APPLICATION NO.	FILING DATE	FIRST NAMED INVENTOR	ATTORNEY DOCKET NO.	CONFIRMATION NO.
10/663,259	09/16/2003	Norman S. Martucci	79287.21520	1456
30734 7590 03/23/2007 BAKER & HOSTETLER LLP WASHINGTON SQUARE, SUITE 1100 1050 CONNECTICUT AVE. N.W. WASHINGTON, DC 20036-5304			EXAMINER AFTERGUT, JEFF H	
			ART UNIT	PAPER NUMBER
			1733	
SHORTENED STATUTORY PERIOD OF RESPONSE		MAIL DATE	DELIVERY MODE	
3 MONTHS		03/23/2007	PAPER

Office Action Summary

U.S. Patent Application 10/663,259 filed September 16,
2003; Norman S. Martucci, entitled "Method of Making
Coated Braided Hose Assembly"; Attorney Docket:
79287.21520

FIG. 3

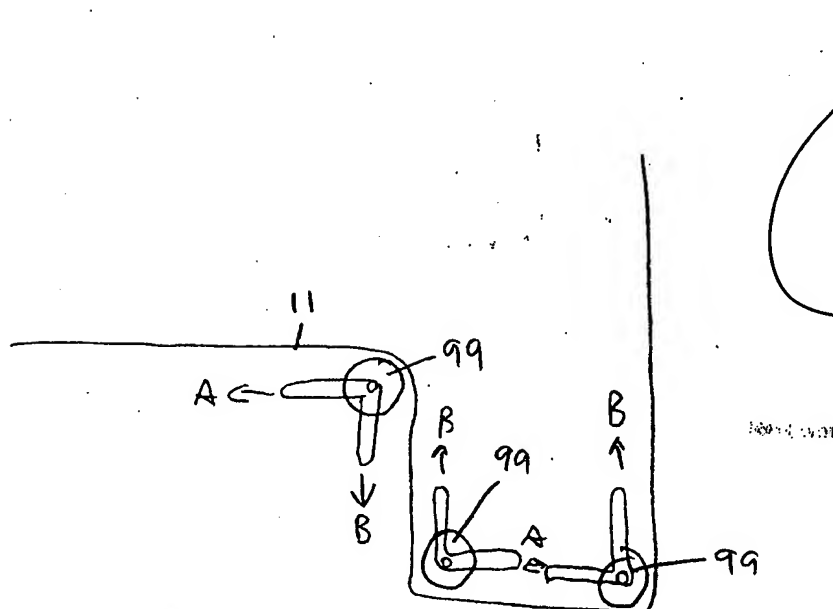
The applicant has presented amended independent claims 1 and 13 for consideration and has added to each of the claims that the "bending devices are adjustable "in at least two directions" and additionally provided a new drawing which is labeled Figure 3 for consideration (to show the adjustability in "at least two directions".

The new drawing appears only to show adjustability in two directions and a very specific manner of arranging the bending devices to allow for adjustability in the horizontal and vertical direction. The applicant is advised that the original disclosure does not support the specific manner in which the bending devices are adjusted as depicted. It should be noted that Figure 3 as provided will not be entered as a new Figure and that Figure 2 should be amended to provide crossing arrows (one arrow in the horizontal plane and another in the vertical plane) adjacent the bending devices in Figure 2 and that the description be altered to state on page 8 that the vertical and horizontal directional adjustments are depicted by the arrows in the Figure. It should be additionally noted that Figure 3 does NOT depict the invention as claimed as the Figure does not provide for more than two directional movement ("at least two directions" infers that there are more than two directions of movement of the bending devices which is not supported by the original disclosure, see below).

5. The proposed new drawing has not been entered, as it appears to add new matter to the disclosure as identifying the specific manner in which the bending devices

are manipulated in the horizontal and vertical directions. It is suggested that Figure 1 be amended by including crossing arrows adjacent or over the bending devices in order to signify that the bending devices can be moved vertically and horizontally in a schematic fashion rather than depicting specific structure for provision of the same. Applicant is additionally advised in this regard that the reference to Figure 3 in the amendment dated

DO NOT
ENTER
